**Date:** 7 September 2018  
**Our ref:** 130797-7  
**Via:** Letter

## 810 Pacific Highway, Gordon: DA610/2017

Reference is made to the planning report prepared for 810 Pacific Highway, Gordon (DA610/2017), planning panel reference no. 2017SNH084, which has been recommended for refusal.

**Figure 1 Amended Plan – Increasing Ground Floor Level RL 126.3**

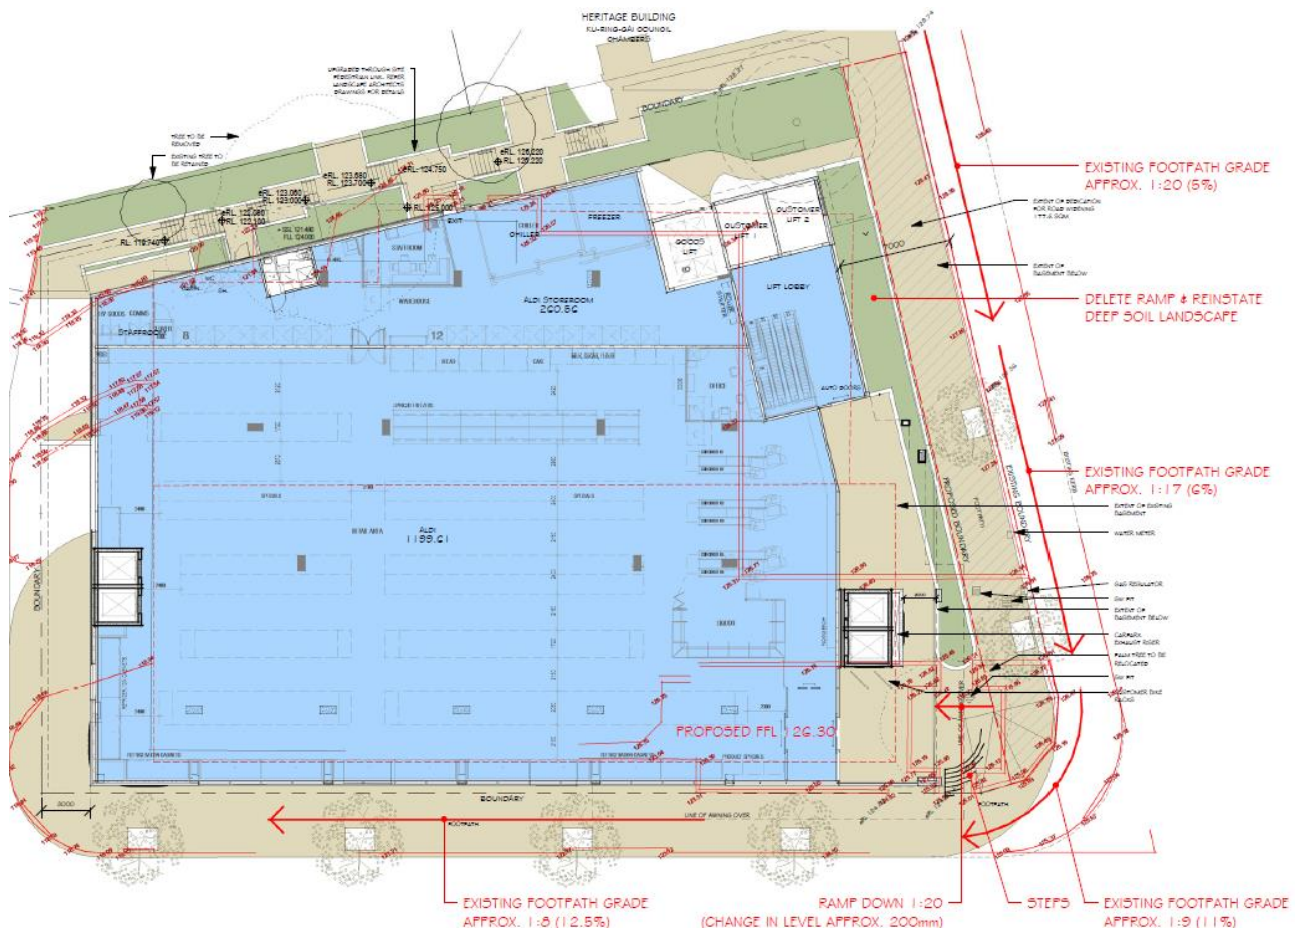
### Amended Plans – Increase GFL, remove ramp & replace with planter

it is proposed to raise the ground floor level by 0.6m and have a reduce floor to ceiling height in the ground floor of 4.4m, whereas 5m was previously proposed. See attached plan & figure 1 below.

- The ground floor level is similar to the ground floor of the existing building and allows for a pedestrian entry just south of the entry to the existing building, therefore making the proposed ramp unnecessary;
- A planter in front of the landscaped podium, to allow for additional landscaping in front of the podium and to the south of the Council Chambers
- Increase the landscaped area and deep soil planting around the Canary Island Palm in order to improve the setting of the heritage item and its view 'in the round'; and
- Improves the level of activation and visibility provided by the ground floor retail space.

However as outlined above and demonstrated in figure 1, an amended plan increasing the finished floor level for the ground floor to RL126.3 has been put forward. This allows the removal of the proposed ramp as the amended floor plan provides a similar path of travel to the existing office block.

The space previously occupied by the proposed ramp will become a landscape area, some of which will be deep soil planting. This also allows for increased space around the transplanted Canary Island Palm and increasing the landscape setback to the heritage listed Council Chambers.

Figure 3 First Pre-DA Scheme – Variance to 15m setback.

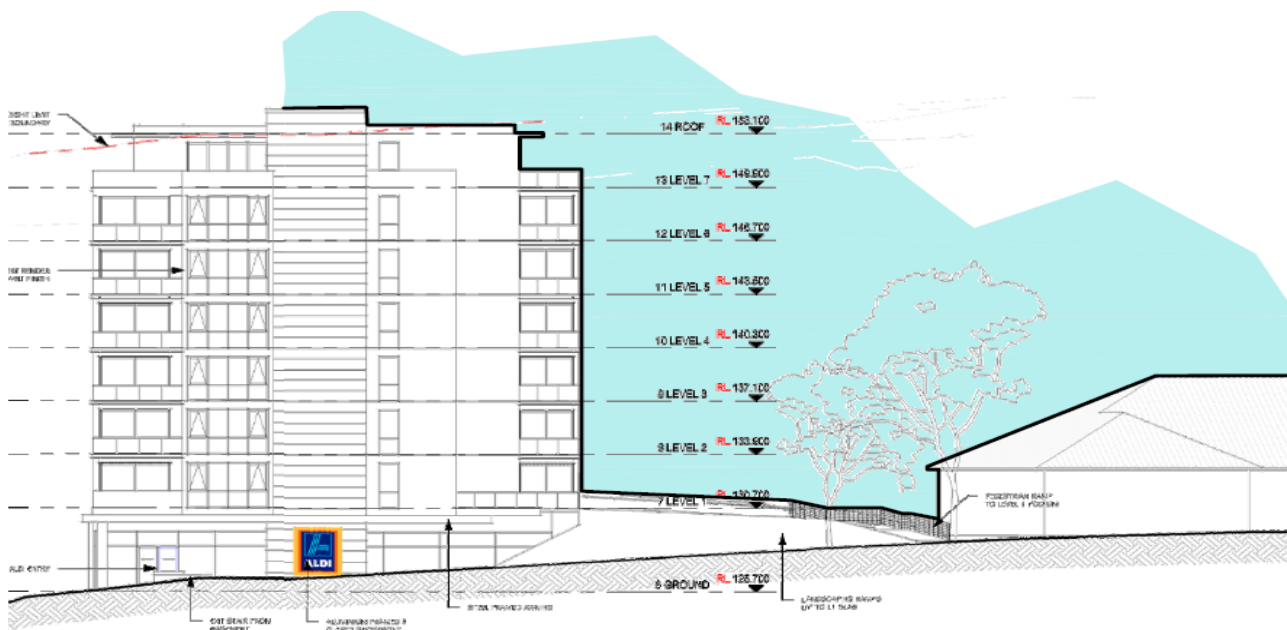
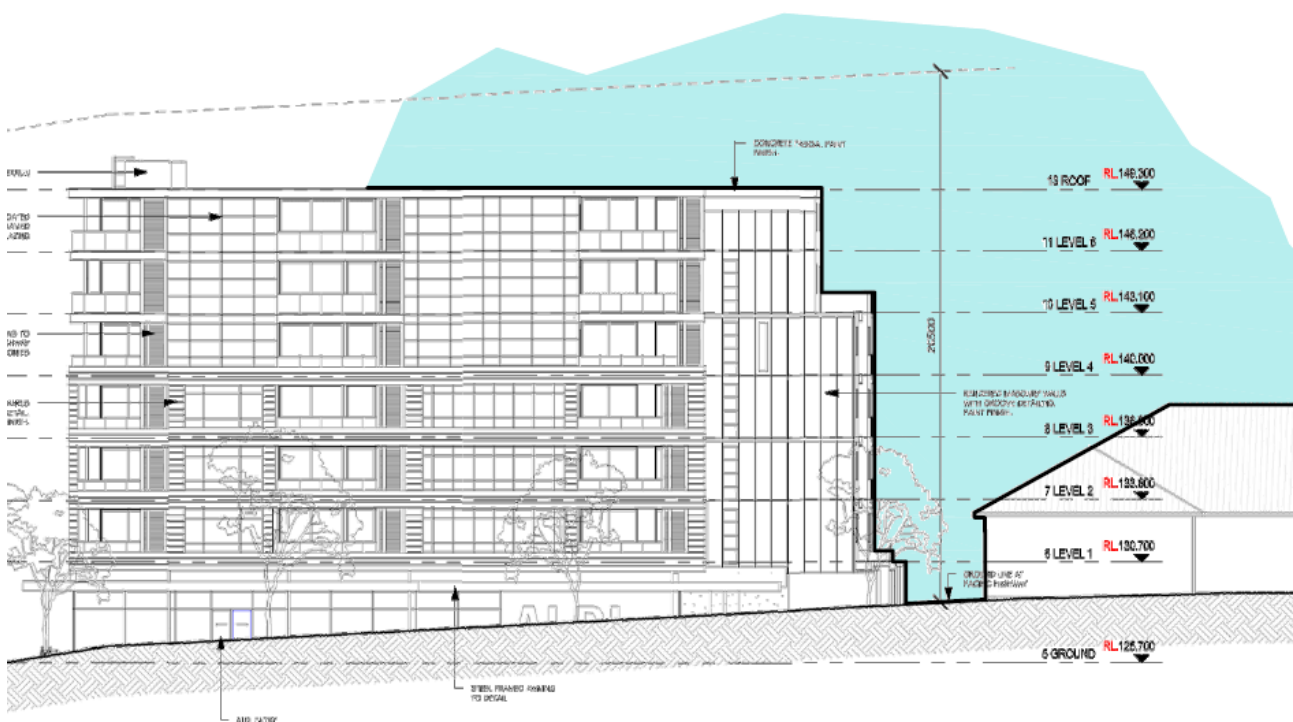
At the first pre-DA meeting the Council's Independent Development Assessment team were presented drawings which proposed a variation to this control and a scheme which was compliant with the 15m setback from the Pacific Highway, in addition to a scheme which proposed a variation to the 15m setback and located the proposed building on the southern boundary with a greater setback to the northern boundary.

As demonstrated in figure 3 and 4 the difference between the two schemes can be clearly seen. Furthermore, the minutes from this pre-DA meeting 28 June 2017 confirm the direction at the meeting which was;

*"A merit assessment to consider a variation to the 15m setback along the Pacific Highway (KDCP\_LC Urban Precincts) needs to be coordinated with Council's engineering requirements for future road upgrades (should there be any) with landscape for tree retention, and heritage considerations. **However, from an urban design perspective, there appears to be potential for a merit assessment for some relaxation of this setback provided there is a well-resolved public domain interface along the Pacific Highway ground plane and the relationship with the Council Chambers building.**"*

Figure 6 Second Pre-DA Scheme Floor Plan Ground

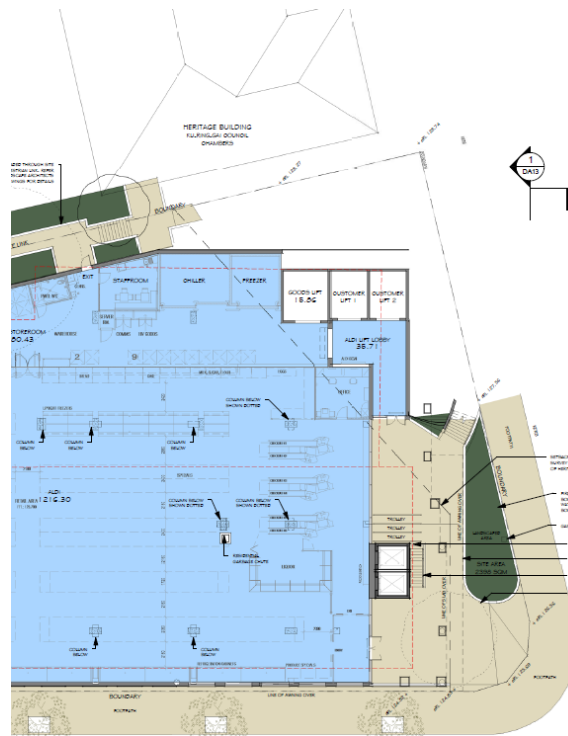
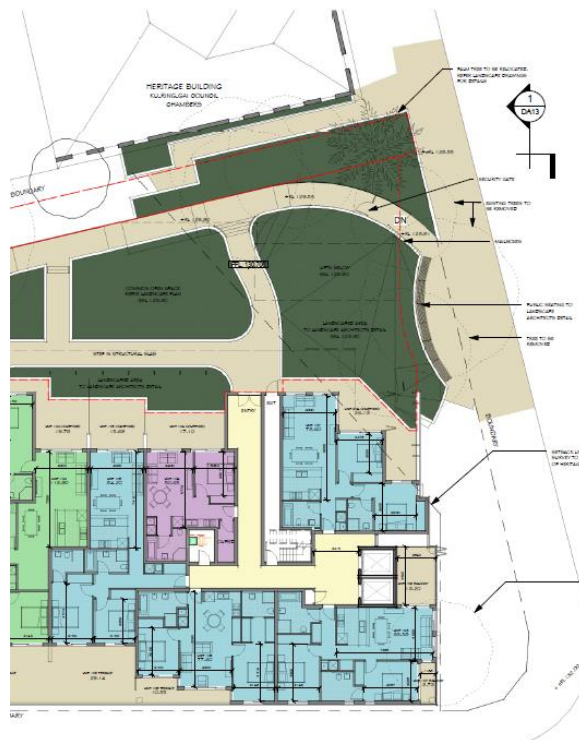
The design therefore was further resolved and subsequently presented at the second pre-DA meeting held on the 13 September 2017 (see figures 3, 4, & 5 below), the following minutes confirm advice received during this meeting;

"Relationship with the Council Chambers building is on the right track with proposed site arrangement so that view corridors can be maintained. (Also see comments on built form.) The elevated residential entry walkway needs further resolution. This may be a good space to accommodate hydrants and other services.

**Figure 8** Revised photomontage taken from the eastern side of the pedestrian crossing outside the Gordon centre.

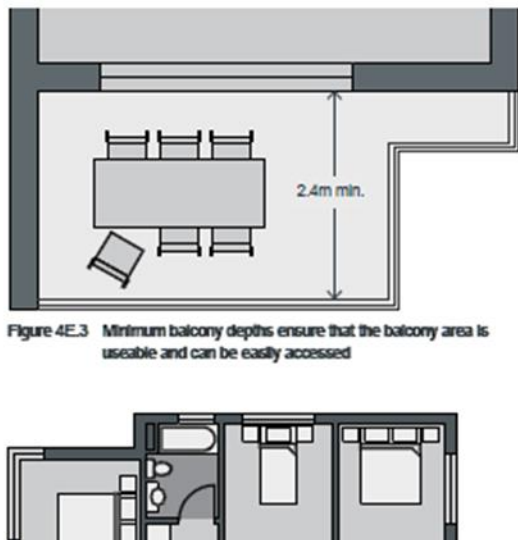
Due to the concerns raised in the reasons for refusal, the open balustrade safety fencing (which appears opaque from the view to the south east of the site) has been setback behind landscaping. Figure 6 below demonstrates that this simple measure greatly improves the ability of a viewer to the south of the Council Chambers to see the subject building 'in the round'. It would also be worth noting that the proposed plants were directed by Council's landscape to enhance the 'old English' setting.

**Figure 10 Proposed Floor plans & balconies to Apartments 109, 210, 310, 410, 510**

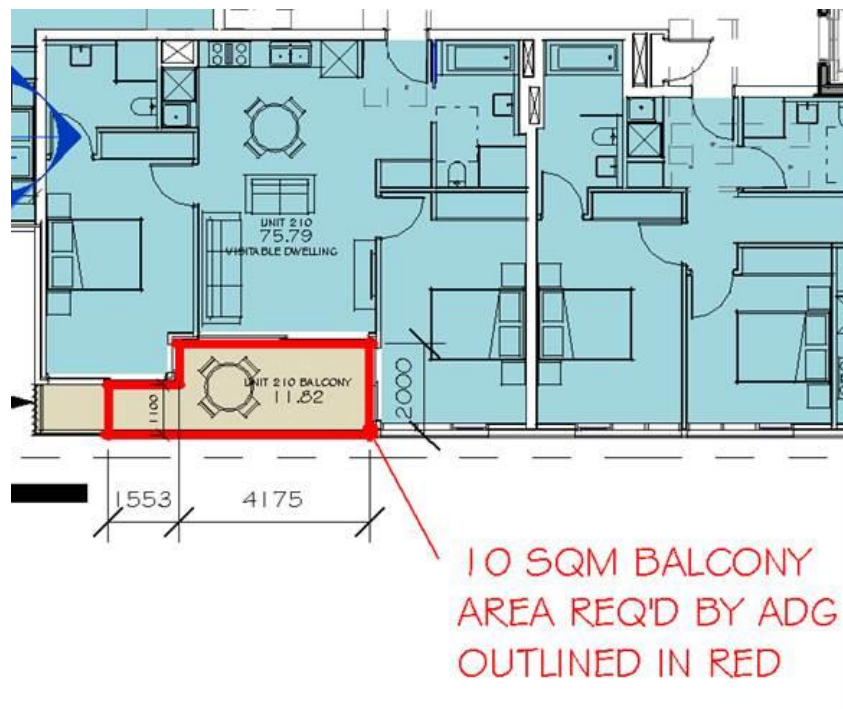
6. *The design provides a poor level of amenity to Apartments 109, 210, 310, 410, 510 and 606 by failing to provide balconies with a minimum depth of 2m as required by Part 4E of the Apartment Design Guide and due to the unacceptable relationship of Apartment 107 with the footpath level and pedestrian access ramp to the supermarket, which would result in unacceptable privacy impacts into Apartment-107 from the public domain.*

At the meeting on 4 May 2018, the Council's Independent Consultant Planner, raised an objection to the design of the balcony for these units because of the 1.1m width in front of the living room, despite noting the south facing nature of the units meant that the 1.1m depth in this location would provide better daylight access into the unit.

The Applicant's Architect noted ADG allows a minimum balcony depth that can be contributed to the required balcony area is 1m and that the design provided a 2m x 3m *usable* space for outdoor furniture, as noted below. The Consultant Planners view was divergent on this issue, however conceded that the argument could be maintained if the living room had direct access on to the wider section of the balcony.

As a result, the plan was amended to locate the usable space for outdoor furniture in front of the living room, and an oversized balcony was provided.

**Figure 11 Proposed Floor Plan & Courtyard to Unit 107**

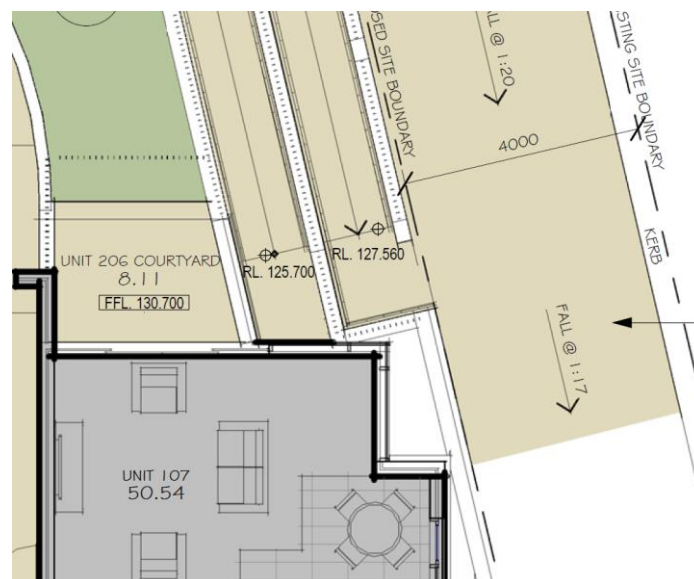
With regards to the relationship between the access ramp & Unit 107, a closer analysis of the plans DA310 illustrates that there is a minimum vertical separation between the top of the ramp & Unit 107 of 3.140m. At the bottom of the ramp this vertical separation increases to 5m, therefore resulting in no privacy issue at this area. This issue would be resolved with the amendment allowing the removal of the access ramp and additional landscaping.

**Figure 12** Ground Floor Plan with Access Grades for Paths of Travel

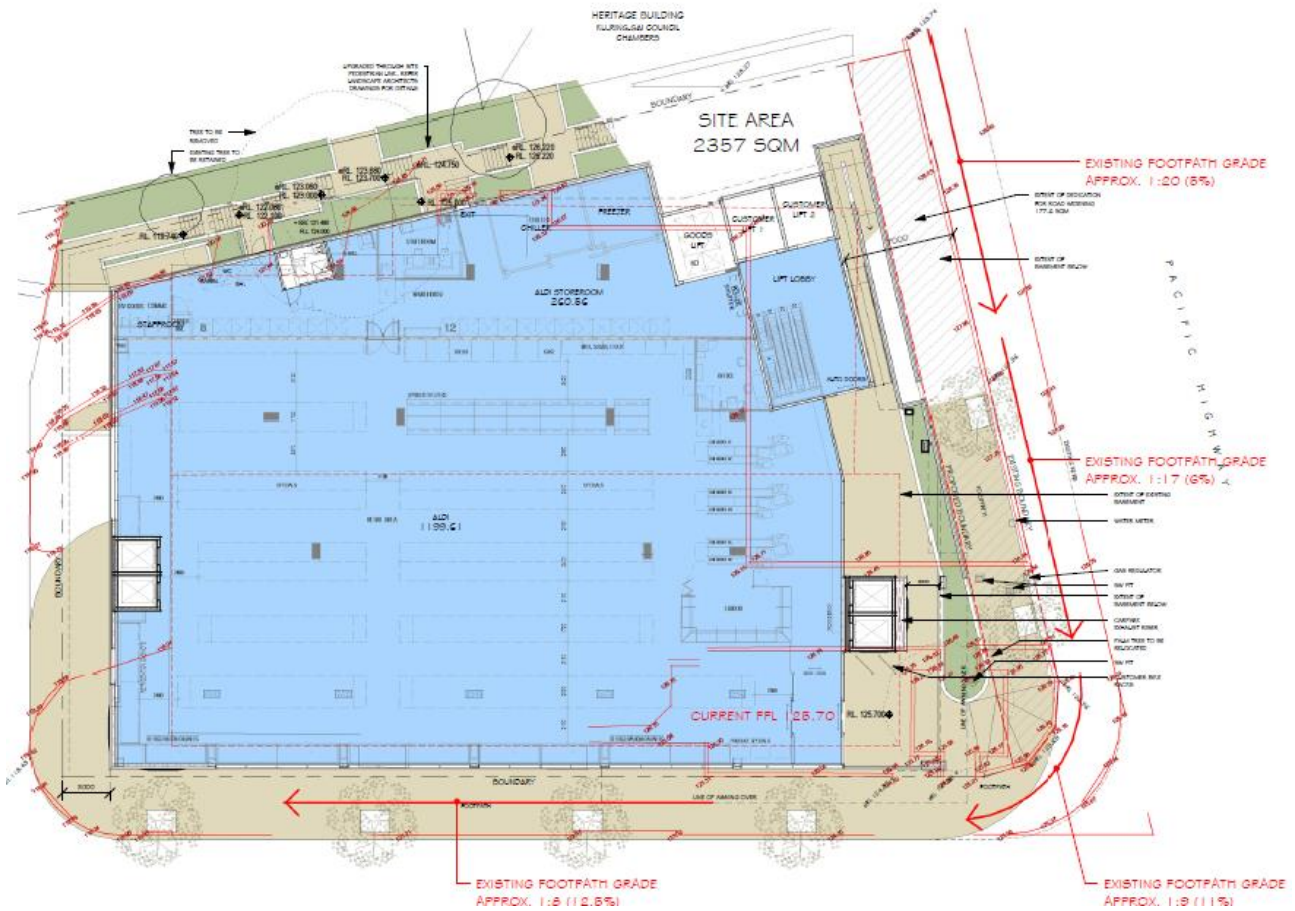
8. *The proposed design of the access ramp to the supermarket is unacceptable, significantly increasing the distance required to be travelled by pedestrians (with trolley, prams or mobility issues) from the intersection of Pacific Highway and Dumaresq Street. The resolution of the pedestrian access at the intersection of Pacific Highway and Dumaresq Street is unclear and would function poorly due to the inadequate front setback in combination with the cross fall of the slope of the site at the south-east corner of the site. The proposal fails when assessed against Controls 2 and 5 of Part 22.1 Equitable Access of Ku-ring-gai Development Control Plan (Local Centres).*

The corner of the Pacific Highway and Dumaresq St falls at 1:10 and the section of the Pacific Highway footpath between the corner of Dumaresq St, the Park Ave crossing falls at 1:17 (as shown on DA310). Therefore, technically the gradient of the existing footpath cannot provide an accessible path of travel into the site from the south.

Anyone with additional access requirements who is able to make the transition across the top of Dumaresq Street from the Gordon Centre and up the kerb ramp and around the corner of Dumaresq Street and the Pacific Highway (which is falling at approx. 1:10) would be able to negotiate the transition into the store at this point as they have already negotiated the kerb ramp and Dumaresq Street corner.

Although the crossfall prevents an accessible path of travel here, there is sufficient space (10m between the new boundary and the front door of the supermarket) to make this transition without steps and at a shallower grade than the existing footpath. Therefore if someone is able to negotiate this crossing, they could negotiate the store entry and would not need to continue up the Pacific Highway footpath at 1:17 in order to come back down a ramp at 1:14.

**Figure 13 OSD Catchment Plan**

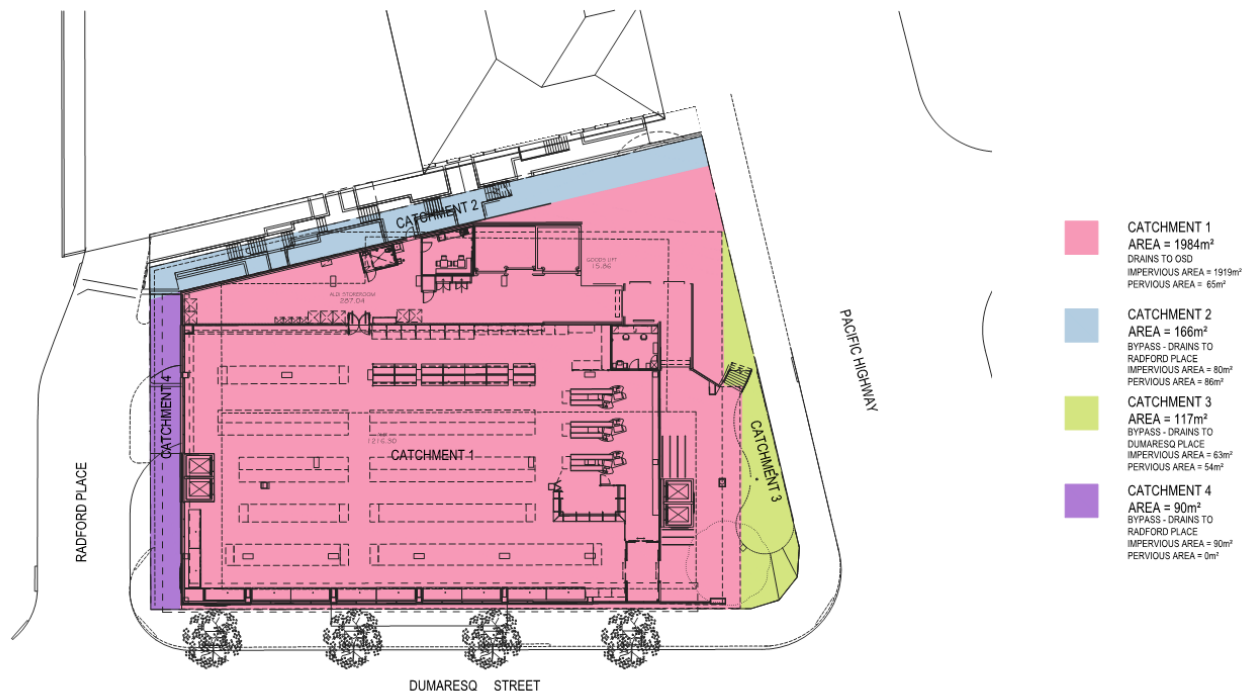
9. *The concept stormwater plan is not acceptable, due to the stormwater from the public pedestrian pathway bypassing the OSD system.*

The existing Ku-ring-gai Council building, and a portion of the Ku-ring-gai Council pathway within the neighbouring Ku-Ring-gai Council site boundary, will overflow in an uncontrolled manner into the subject site. Connection of a stormwater system within the footpath/through link to the site OSD system would introduce external catchment runoff into the OSD system and is not in accordance with Ku-ring-gai Local Centres DCP requirements and standard OSD design practice.

Notwithstanding the above, we have modified the site catchment calculations and OSD Permissible Site Discharge (PSD) flow to account for the pedestrian footpath/through link. A Catchment Plan, Civil Drawing C5.01, has been prepared to demonstrate OSD and Bypass Catchments (see Figure 12 below).

It is proposed that surface drainage structures within the pedestrian footpath/through link will collect stormwater runoff from paved and landscaped areas. The through link stormwater system will then discharge to a kerb outlet within Radford Place. The approximate 5% AEP discharge for this through link will be 17 litres per second, which is below the maximum 25 litres per second allowable under Ku-ring-gai Local Centres DCP requirements. The proposed stormwater system for the through link is documented on Civil Drawing C2.01.

The accompanying OSD Calculation Sheet on Civil Drawing C1.06, has been updated to include all bypass areas, as shown on the above Catchment Plan. We note that the ratio of Bypass Impervious Area to Total Impervious Area is 0.11, which is less than 0.25 as required by Ku-ring-gai Local Centres DCP. The orifice diameter to the OSD tank has been modified to the new PSD rate.
